**NOTICE OF A JOINT MEETING OF THE HISTORIC PRESERVATION COMMISSION
AND TOWN COUNCIL OF THE TOWN OF CLARKDALE
TUESDAY, FEBRUARY 6, 2024 AT 6:30 PM**

Agenda Item:**Clarkdale Bandstand**

CLARKDALE BAND STAND

RE: Town of Clarkdale, Yavapai County; Clarkdale Band Stand; Non-Mandated Review; Clarkdale Park, SHPO-2023-0768 (172498)

Photo 8 – Poor condition at base of column

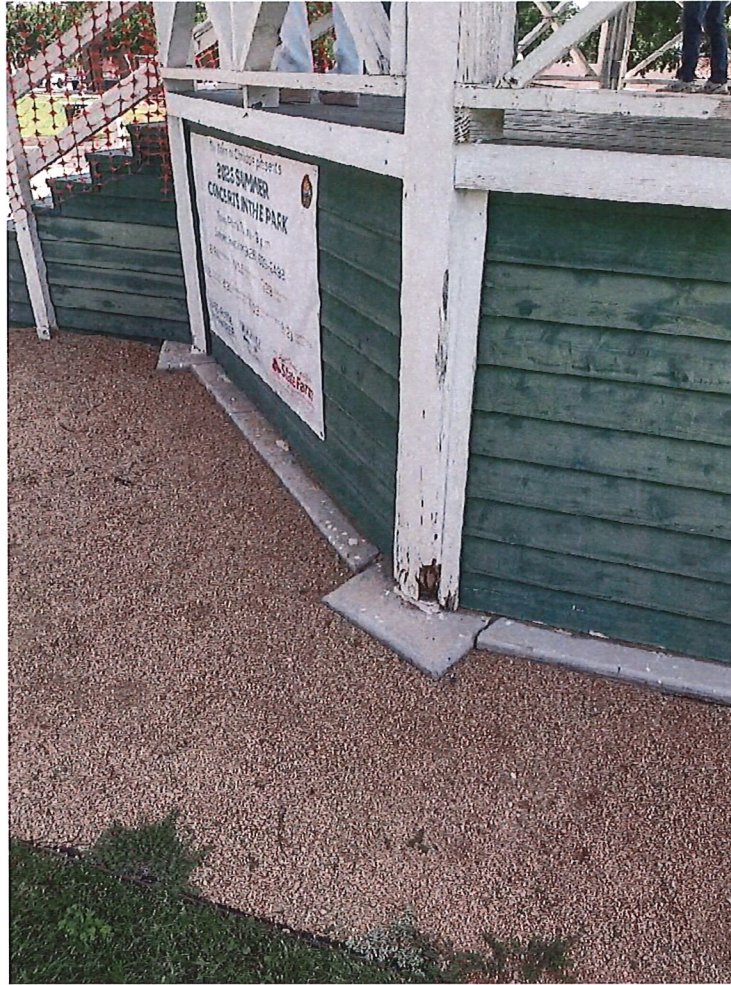
- *Columns:* The eight 6x6 wood columns are the most visible outline of the structure. Each has damage, primarily from wood rot and disintegration at the base, some more extensively than others (see photos 8). Each of the columns, whether above the floor line or below, shows some degree of being out of plumb. Heavily painted, it is not discernable by cracks or other stress indicators if the alignment is due to shifts in the structure or ground support or is from the wood drying and twisting or is the alignment of the wood when originally placed in the structure.

- Replacement of all columns. Each has some degree of displacement in its alignment vertically. Individual replacement could be accomplished by removing and replacing the column while bracing and blocking the rest of the structure in place. The insertion of new columns would likely entail significant customization of all of the effected connections to each column.

Photo 10 – Railings at Column – Wires at Railings

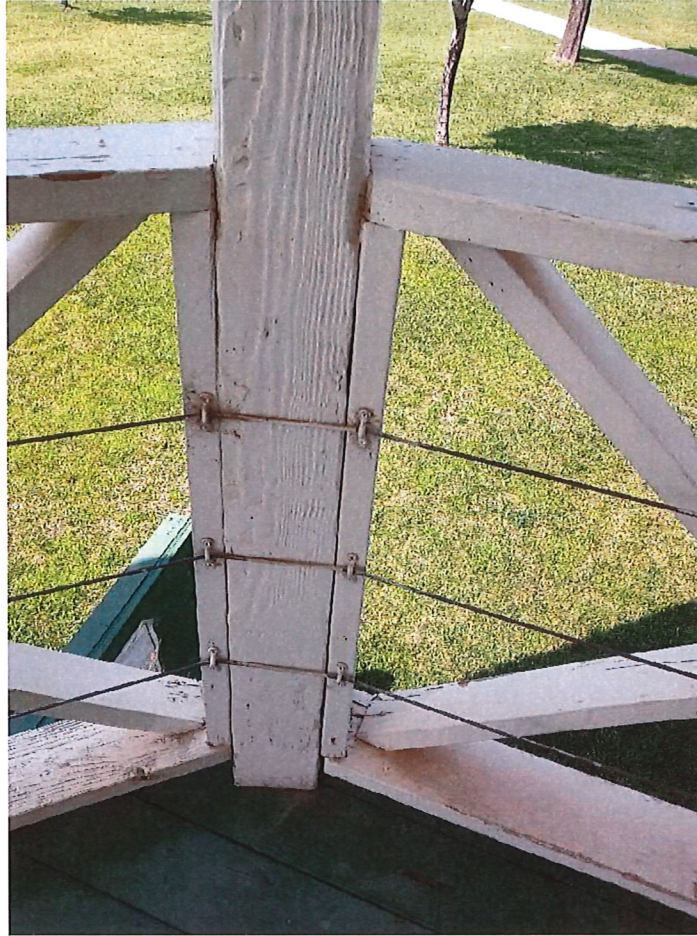
- *Railings:* With the exception of staircase location, each pair of columns has a handrail supported between them and above the floor. The rectangular frame and mid-vertical are of 2x6s and the diagonals within each box are 2x4s. All connections appear to be nailed. (See photo 9). Additionally 3 wound wire cables are attached to interior sides of the railings. (See photo 10).

Railings: The railings are required to support a 500 lbs load applied laterally. The 2x6 rails bending stress for such a load is minimal, however, the shear load of 250 lbs at each end exceeds the capacity of nails whether in shear (138 lbs per nail) or pull out (40 lbs per nail) as the angle of each nail with respect to the load is uncertain and some reasonable percentage combination of the strengths would be applied as well as some amount discounted. These are considered to be unsafe.

- Rebuild the railings. There are several architectural approaches to the appearance but the minimal approach would place bolts through the columns for connections at the end of the railings.

Photo 11 – Staircase

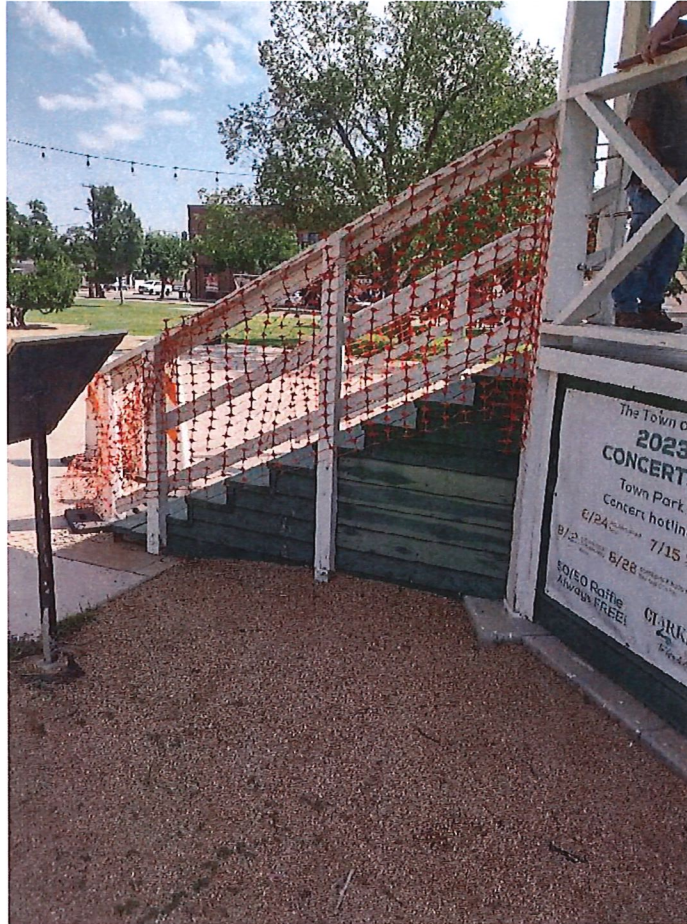
- *Stairs:* The staircase consists of nine (9) 11" steps with nine (9) 6" risers and one half size riser at the bottom. The steps span the opening between two columns and consist of the same 2x6 planks found on the octagon deck. The handrails span two 4x4 columns at the bottom and middle and connect to the 6x6 columns at the top. Three 2x6 planks, evenly spaced form the rails with a 2x6 placed flat on the top rail and columns. A 1 1/2" +/- tube rail is attached to the top wood rail on both sides. The bottom end of the staircase appears to rest on the adjoining Clarkdale Park central patio, separate from the concrete work supporting the band stand and spanning between. (See photo 11)

Option 1 will cause the bottom stair riser to be elevated one foot above the park patio (with a requisite extension of the stair, not mentioned in the ASE report). Raising the entire structure is a dramatic solution, typically chosen for flooding scenarios rather than correcting poor site drainage. Additionally, Option 1 would alter visible foundation walls to an extent that the historic character of the Band Stand may be adversely impacted, particularly because this is a small stand-alone structure. Therefore, SHPO recommends Option 2 is pursued. Option 2 is preferred because it retains the historic relationship between the bandstand and its site and setting, does not alter the character of the structure, and does not require an extension of the stair, all while maintaining a concrete barrier between grade and the wood structural system required to keep the Band Stand dry.
